Service Bulletin

Bulletin No.: 15-NA-051

Subject: No Start/Stall - Seat Bottom Contacting Rear Electrical Center (REC)

Brand:	Model:	Model Year:		VIN:		Engine:	Transmission:
		from	to	from	to		
Buick	Lucerne	2008	2011			All	All
Cadillac	DTS	2008	2011

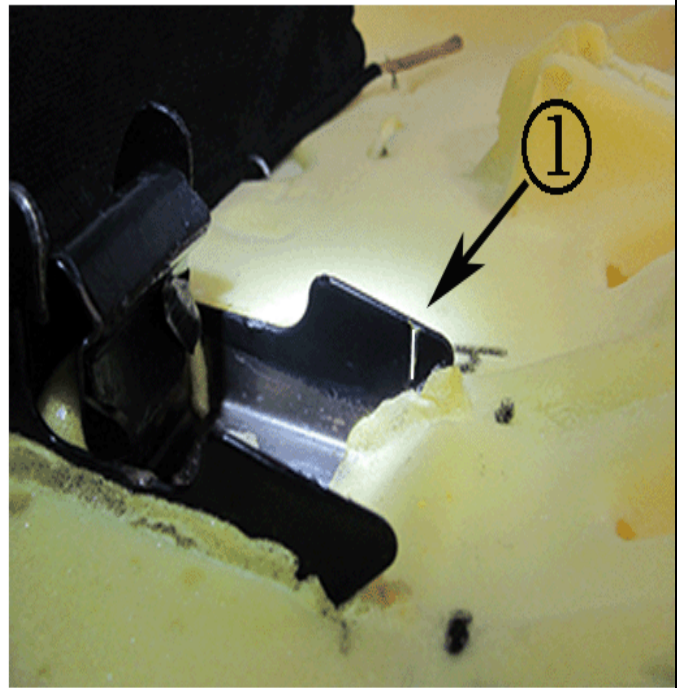
Involved Region or Country	North America and N.A. Export Regions
Condition	Some customers may comment on a no-start or stalling.
Cause	The rear seat bottom may come into contact with the rear electrical center (REC) cover. The contact/interface results in varying amounts of deflection of the fuel pump relay (FPR). The movement of the FPR causes potential wear of the male terminals on the FPR.

- Install a low profile fuel pump relay (DTS and Lucerne).
- Remove material from the rear seat bottom frame, driver side mounting brackets (Lucerne Only).

4294550

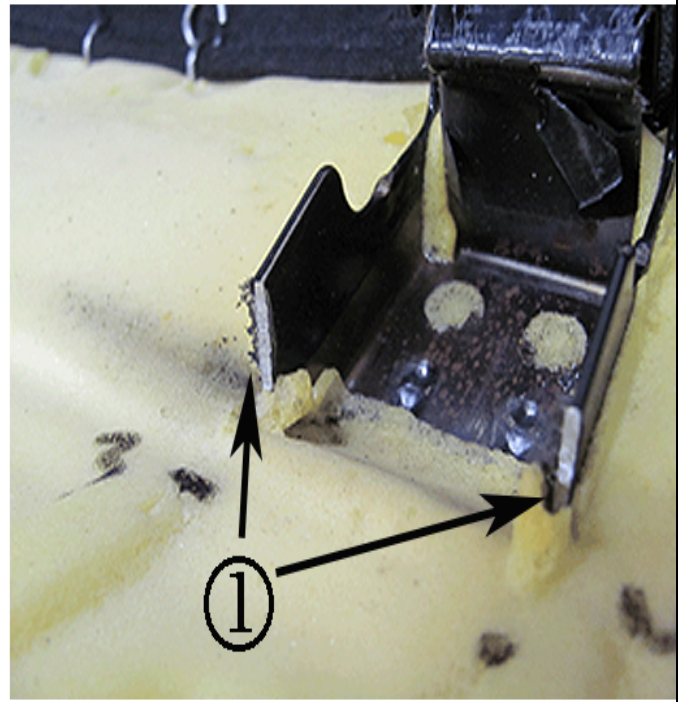
6. For Lucerne only, with the rear seat cushion on a bench, measure 5 mm (0.197 in) from each edge of the right side seat mount bracket and mark with a paint marker as shown (1).

7. For Lucerne only, using a cut off wheel or equivalent, carefully cut each side of the bracket as shown (1). Check for any rough edges and file if necessary.
8. Install the rear seat cushion and close door.
